HISTORIC AND DESIGN REVIEW COMMISSION

HDRC CASE NO: 2021-164
ADDRESS: 315 E PECAN ST
LEGAL DESCRIPTION: NCB 413 BLK 11 LOT 3-4- 5, 6 & E 27.8 FT OF 2
ZONING: D,HE
CITY COUNCIL DIST.: 1
LANDMARK: St Mark's Episcopal Church
APPLICANT: Tobin Hays/Ford, Powell and Carson Architects and Planners
OWNER: Eric Nelson/ST MARKS EPISCOPAL CHURCH
TYPE OF WORK: Window replacement
APPLICATION RECEIVED: February 04, 2021
60-DAY REVIEW: Not applicable due to City Council Emergency Orders
CASE MANAGER: Stephanie Phillips

REQUEST:

The applicant is requesting a Certificate of Appropriateness to replace all existing six over six wood windows on the 1920s Parish Hall and 2012 addition with new aluminum clad wood windows to match the historic windows in profile, inset, configuration, and detailing.

NORTH ELEVATION

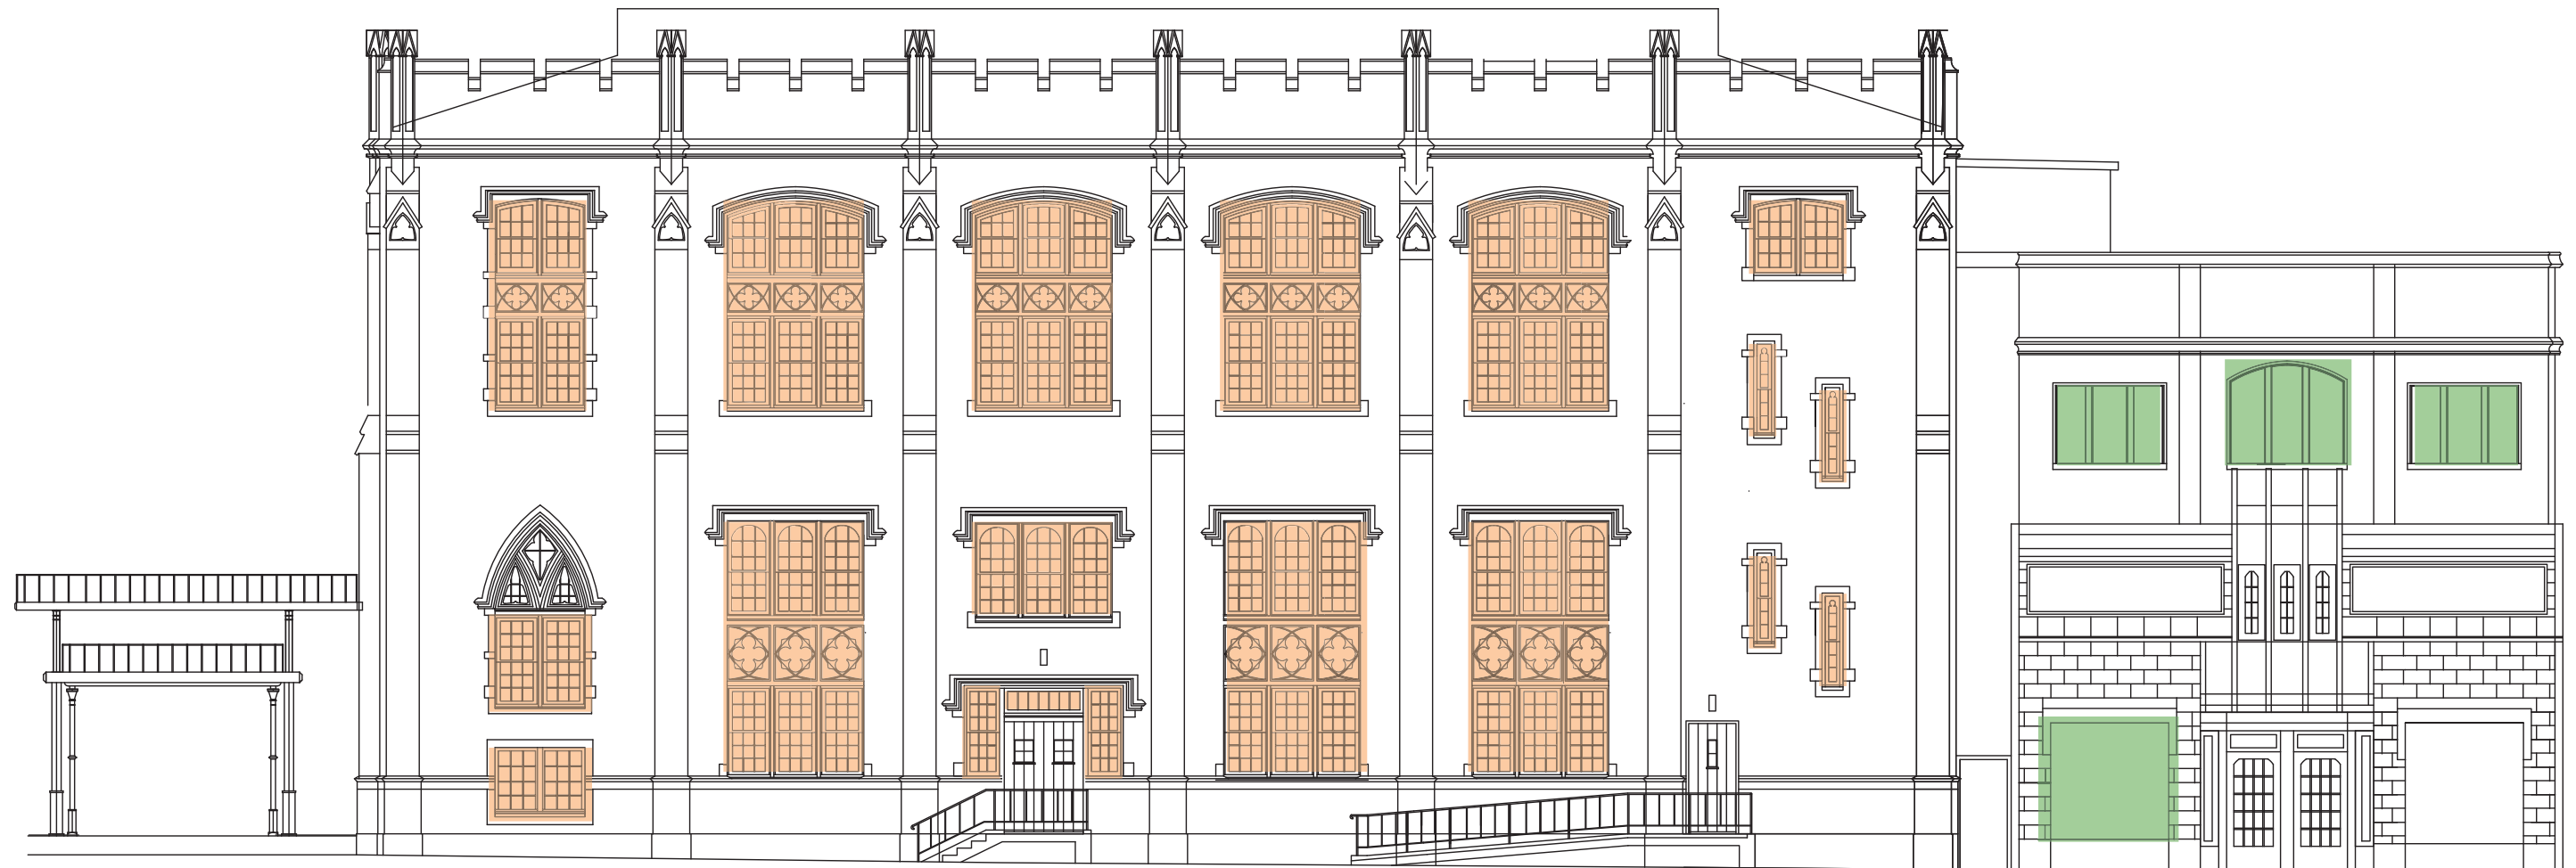
■ RESTORE WINDOW
■ REPLACE WINDOW

- i. That the applicant restores the original wood windows on the first floor as noted in finding d. If, when undergoing repair, the applicant finds evidence of deterioration beyond repair of an assembly (more than 50 percent of original wood components require replacement) on the first floor, the applicant may relocate repairable windows from the upper floors or other portions of the building where matching windows are available. Updated repair and/or relocation plans are required to be submitted to staff over the course of construction for review and approval, in addition to extensive documentation illustrating deterioration beyond repair.

- ii. That the new replacement windows for the upper stories match the existing in terms of size, configuration, true divided lites, and inset. Openings shall not be modified to accommodate stock sizes. Final drawings and product specifications are required to be submitted to staff for review and approval prior to the issuance of a Certificate of Appropriateness, and a mock up must be installed on site for field verification.
